Subject: Encroachments into the ROW beyond the property line.

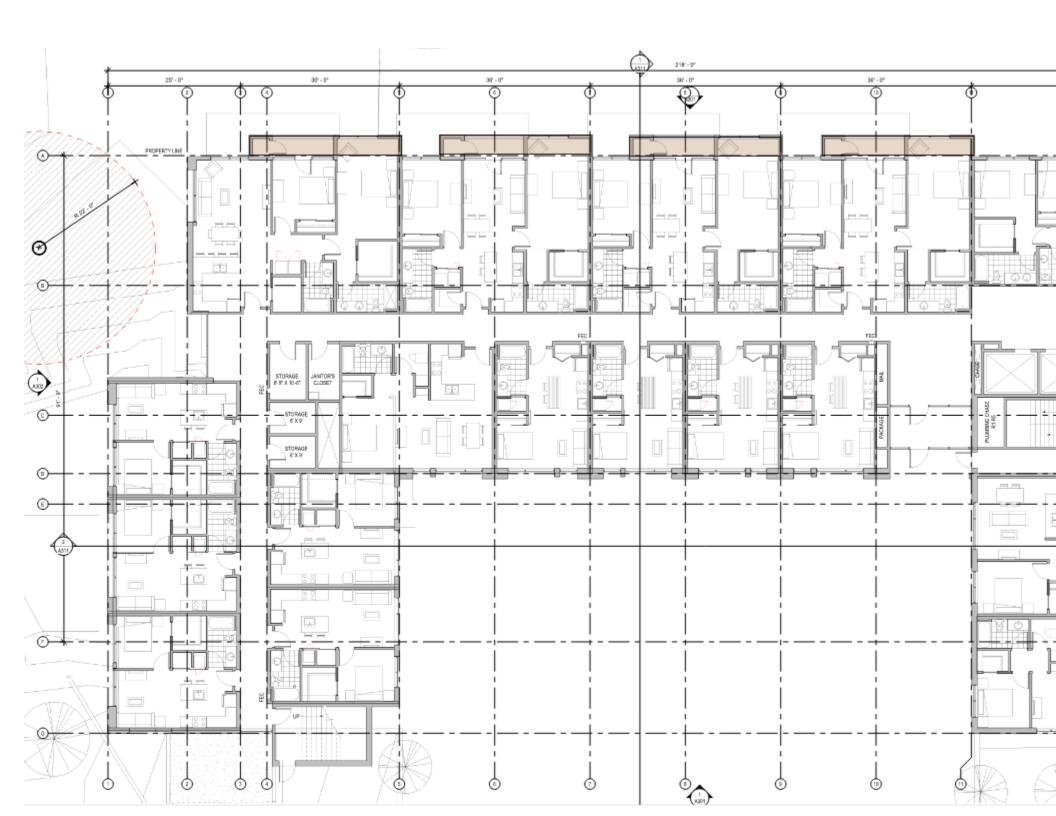
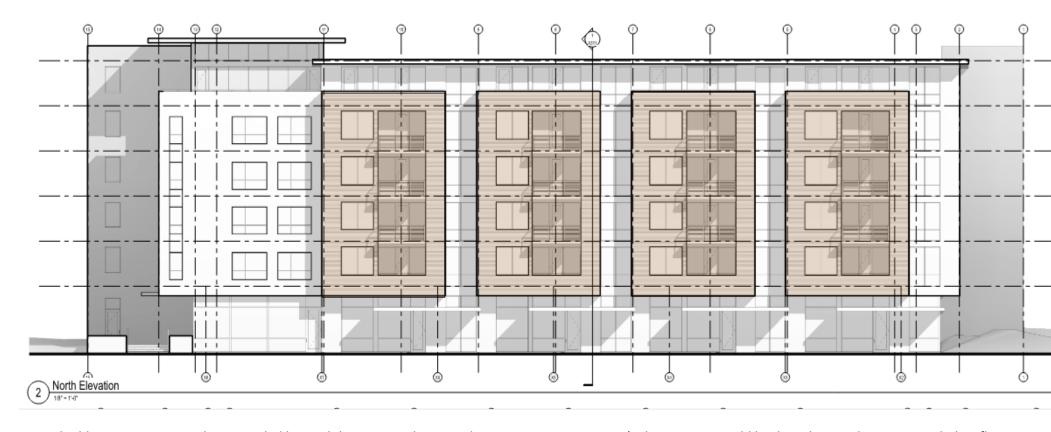
Here is the proposal which shows the cantilevered floors projecting into the ROW beyond the front property line. Let me know if this helps or if you'd like additionally added to the proposal which shows the cantilevered floors projecting into the ROW beyond the front property line. Let me know if this helps or if you'd like additionally added to the proposal which shows the cantilevered floors projecting into the ROW beyond the front property line. Let me know if this helps or if you'd like additionally added to the proposal which shows the cantilevered floors projecting into the ROW beyond the front property line.

A past build in our juristiction that extended beyond the property line into the ROW IBC 3202.3 over 8'. The concern would be the substantial structure including floor area, respectively.
